U.S. DEPARTMENT OF THE INTERIOR
BUREAU OF RECLAMATION
NAVAJO-GALLUP WATER SUPPLY PROJECT
NEW MEXICO

SAN JUAN LATERAL - BLOCK 2 - 3

REACH 3 - LINE PIPE

PLAN AND PROFILE

1695-D-60794
SHEET

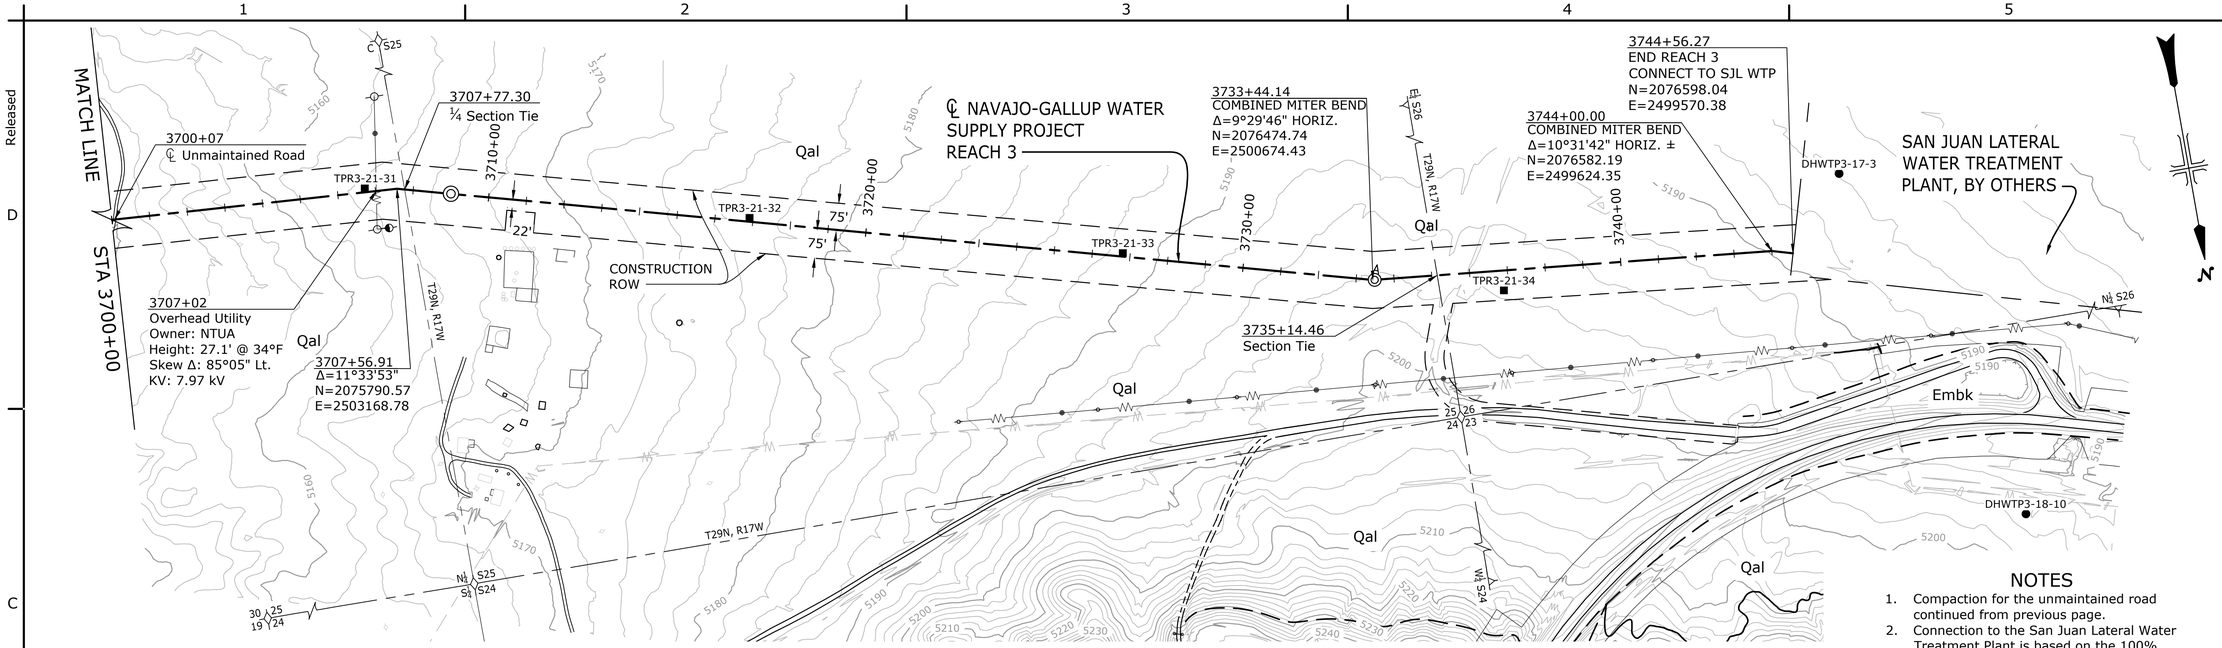
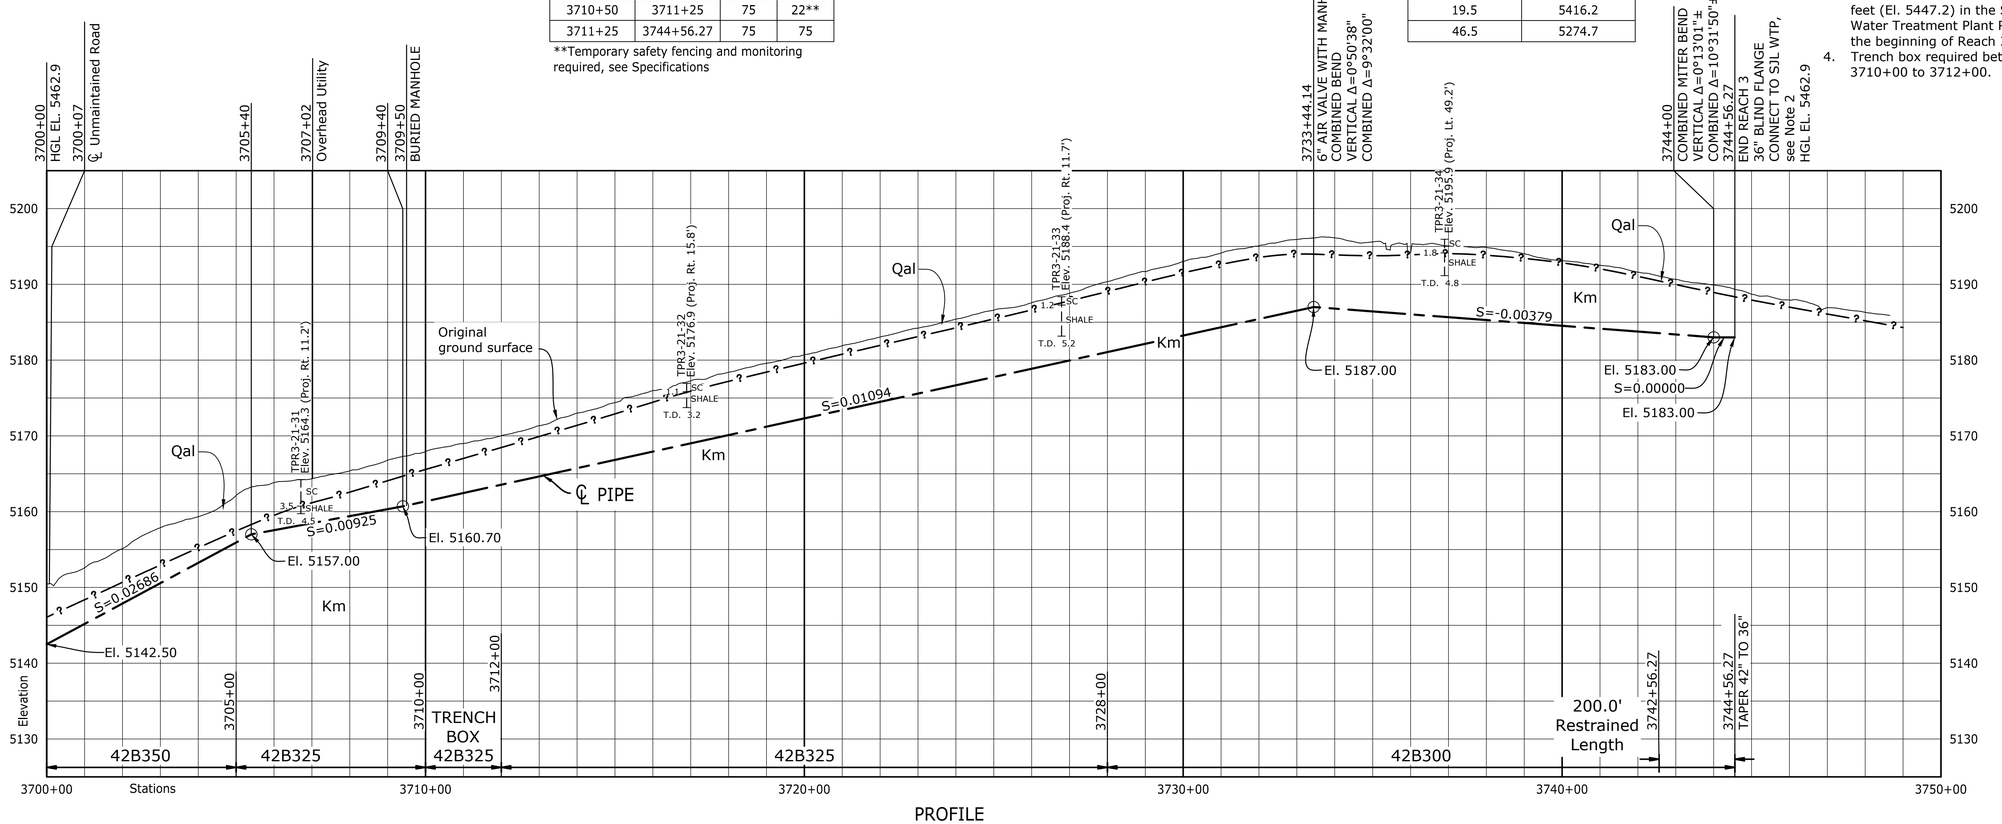
REV NO			
1	D	2026-05-18 Marner, Andrew (Andy) J P.E.	Removed sewer bore for powerline crossing at Station 3707+02.

2 VALVE ID PLATE

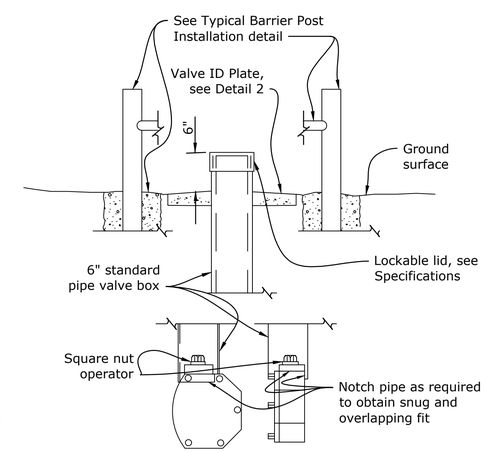
REV NO	DATE	DESCRIPTION	BY
1	2026-05-18	Revised valve id plate anchors to stainless steel	Marner, Andrew (Andy) J P.E.
